# RECOMMENDATION PROPOSAL

8511 15TH AVE NW, SEATTLE, WA 98117

PROJECT #:3035869-LU

EAST ELEVATION ALONG 15TH AVE NW

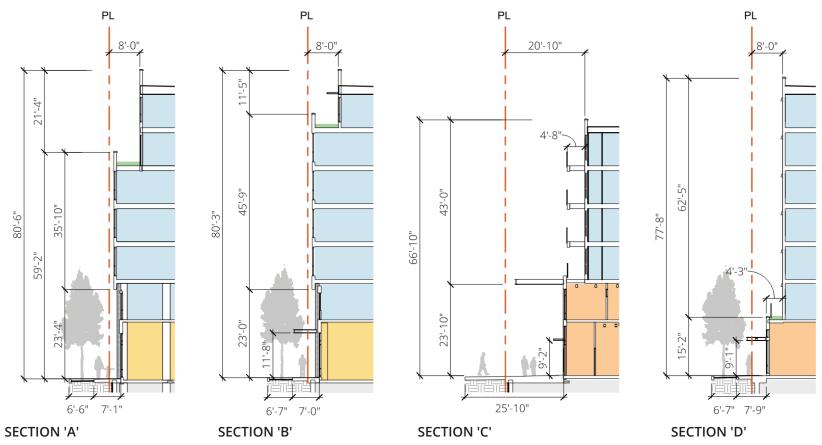
Clear guidance was provided at EDG and in subsequent corrections that the scale of this project, and particularly its great length, required mitigation to better fit with existing context. The intent to do so with a two-part massing scheme has been supported throughout, with specific guidance to strengthen its legibility through the development of related but recognizably different expressions. For this approach to be successful it is essential that the two masses be differentiated enough that they read as two different, smaller masses that together make the whole. In the current design (as with the previous iterations), it is the lack of differentiation between the two masses that limits the scale mitigating effect of this approach. CS2-D, DC2-A, CS3, DC2-B).

RESPONSE: At each phase of the design review process changes have been made in response to guidance to mitigate the size, bulk, and scale of the project as well as differentiate the two large building masses. This has created two distinct but conceptually connected architectural expressions.

In response to Correction Notice #4 (July 9, 2021) the window articulation on one of the larger masses along 15th Ave NW has been revised to create a unique composition. Additionally, the exterior finish scheme has been modified to provide clear distinction between the two individual masses. Note: a complete list of revisions made in response to guidance related to scale mitigation, composition, and context has been included for reference.

**SOUTH ELEVATION ALONG NW 85TH ST**

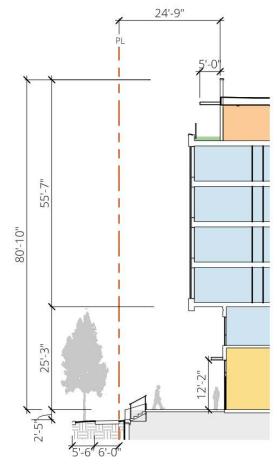
The development of depth in the upper massing helps differentiate this element and strengthens composition and scale mitigation, particularly on the east elevation. At the South elevation this continues to creates depth and texture (DC2-C, DC2-D) but the static horizontality of this facade emphasizes rather than mitigates project scale and requires refinement. Introduction of a differently scaled element that breaks up that horizontality could provide mitigation and help the project better fit existing context. (DC2-B, CS2-D)

RESPONSE: The scale of the south elevation and tangentially the scale of the southeast corner has evolved throughout the design review process. Several large massing changes along with smaller detailed compositional revisions have all been made in response to guidance related to the composition and scale of the facade.

Vertically the south elevation is divided into three distinct zones. The lower zone consists of the two story masonry podium which includes large punched openings of storefront glazing and overhead canopies along the full extent of the south facade. The upper section is setback from the dominant facade creating functional outdoor amenity space which is accented with continuous upper level canopies. The middle section of the facade includes several horizontal changes in plane which adds depth to the mass and creates a unique corner expression. Recessed windows and distinct material transitions including large vertical sections of corrugated metal panels create additional articulation in the composition which is reflective of the existing built environment while simultaneously creating an appropriate precedent for future development in this evolving neighborhood.

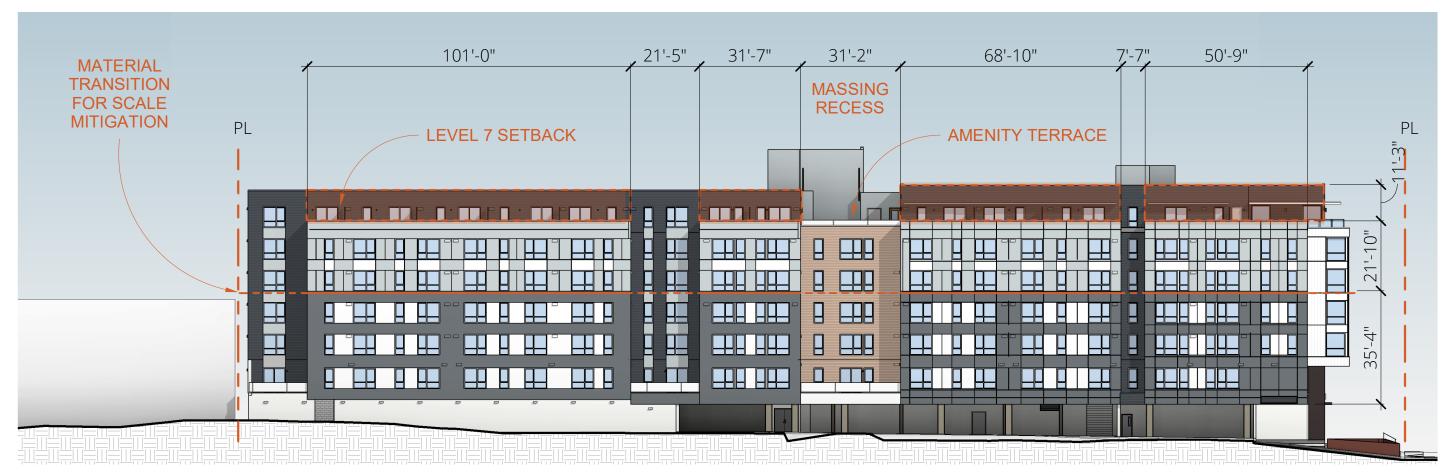
ARCHITECTURAL CONTEXT: EVOLVING NEIGHBORHOODS (CS3-A-4) Staff recognizes the design challenges for this project created by the great length of the site and by the much smaller built environment on 15th Ave NW.

Staff suggests the development of a wider variety of heights (or perceived heights) for the massing elements, noting that the proposal of a uniform structure height for 360 ft of street frontage at this location would create difficulty for the proposal to meet the Design Guideline criteria.

Along both street frontages, the building is broken up by high contrast material transitions at the pedestrian level, distinctive massing articulation along the entire length of the facade, horizontal setbacks which create impaction outdoor amenity spaces on multiple levels, and modulating canopies at the street level which result in a dynamic pedestrian experience.

The horizontal modulations and detail elements implemented at various locations help to break down the overall length of the facade resulting in a perceived scale that is responsive to the existing built environment.

SECTION 'F'

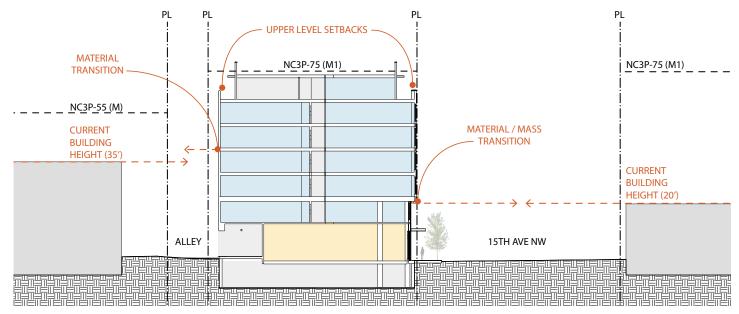
Staff notes the zone transition to a less intensive zone at the West property line. A step in perceived height, bulk and scale will be necessary between the anticipated development potential of the adjacent zone and the proposed development.

The West elevation is broken down utilizing a similar two-part massing strategy which is implemented on the east elevation. The distinctive north and south masses are broken up by a large recessed massing element near the center of the building. This area is unique in material composition, and vertical dimension and is set back significantly from the dominate face of the building creating outdoor amenity terraces on both the 2nd and 7th levels.

Additionally, a deliberate and unmistakable transition of horizontal materiality along a significant portion of the West elevation creates a perception of varying heights which mimic the anticipated development potential of the abutting sites.

The change in materiality along with deliberate upper level setbacks work in conjunction to break down the overall bulk of the building and create an appropriate transition from the adjacent zoning.

PLAZA DESIGN INSPIRATION

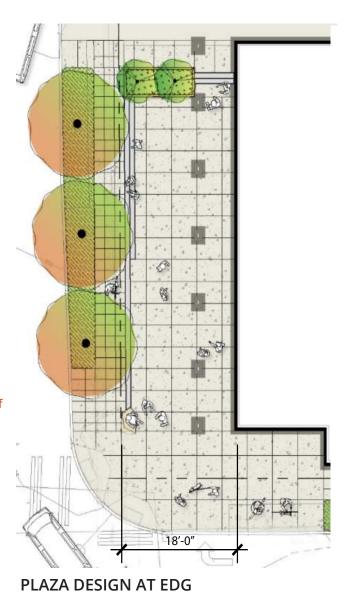
CONNECTIVITY: NETWORK OF OPEN SPACES (PL1-A-1) Staff supports the idea of open space at the corner of 15th Ave NW and NW 85th Street, with guidance to articulate this area as a recognizable "place" available for public use and create a design that invites and encourages public activity.

The plaza proposed at the corner of 15th Ave NW and 85th Street will become a gateway to the evolving Crown Hill neighborhood. The plaza will be a natural opportunity for outdoor dining and other commercial activities but function as a landmark and gathering place for residents of the building and the surrounding community as well.

The plaza has been widened to facilitate a wider range of both public and private uses. Greenery is hosted in raised planters which frame the plaza on two sides. This arrangement creates a recognizable sense of place. The angle of the planters anchor the welcoming plaza entry, while two large exterior stairs provide multiple points of pedestrian access along NW 85th Street and create an open circulation corridor for the neighborhood.

Distinctive pavers, outdoor furnishings, accent lighting, and a landmark sculptural art piece, all reinforce the uniqueness of the space and contribute to a dynamic public plaza that will become a functional amenity for the project and an distinguishable improvement to the larger neighborhood.

SECTION 'B'

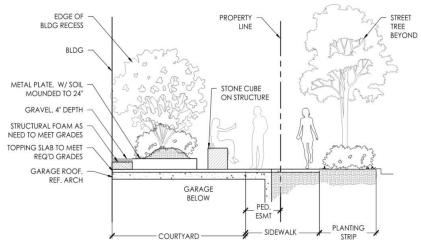
Staff supports the indication of a unique and large-scale expression for the principal residential entry which should be developed to create an entry that is obvious, identifiable, and distinctive with clear lines of site to the lobby from the street and that is welcoming and identifiable to visitors.

This can be accomplished with a combination of elements overhead and in the ground plane, unique doors, transitional space, porches, seating walls or areas, as well as with lighting, landscaping, signage and expressive architectural detailing. (PL3-A, PL3-B)

The main residential entry is located at the base of the large recess that separates the two larger building masses. This setback from the street frontage creates a natural transitional space that is distinct and immediately identifiable to residents and visitors.

A distinctive wood entry door, oversized address numbers, and a large angled canopy structure over a two-story glazed facade highlight the residential entry. Large areas of glazing on all three sides of the provide clear lines of site to the lobby and adjacent commercial spaces.

Distinctive landscaping, landscape lighting, and integrated outdoor seating elements help to create a cohesive and unmistakable entry expression that is visually striking, while remaining secure and providing a buffer of semi-private space between the residential entry and the street.

**MATERIAL PROPORTIONS - NW 85TH STREET**

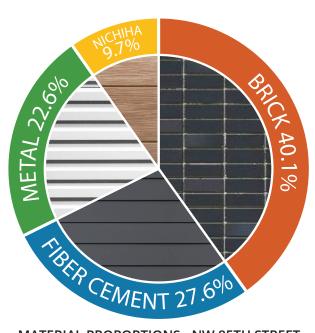
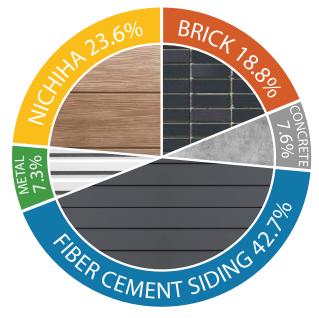
Exterior Materials (Correction Notice #4 - July 9, 2021) The Design Guidelines call for the use of high-quality exterior materials that lend themselves to a high level of detailing, have texture, pattern, or integral color, are attractive when viewed up close, have sufficient thickness to prevent warping or deformations, do not depend on paint for a finish and demonstrably age well in Seattle's climate. (CS3, DC4-A.1, DC4-A2, DC4-1.c, DC4)

**RESPONSE:** High quality exterior materials are proposed extensively on the two principal street facing facades. Specifically the lower street level elevations are exposed concrete or clad in integrally colored masonry. The projecting masses are clad in wood toned or metal panels of varying texture which will be specified in an appropriate thickness to prevent warping and deformation. Fiber cement siding is specified only on recessed portions of both principal facades and is applied predominately as a lapped plank product. This application will provide texture and minimize potential for deformations or distortions over time. The siding is specifically engineered for regional climatic conditions in the Northern US and Canada. The product resists shrinking, swelling and cracking and has been installed successfully on a multitude of projects within Seattle of a comparable type and scale.
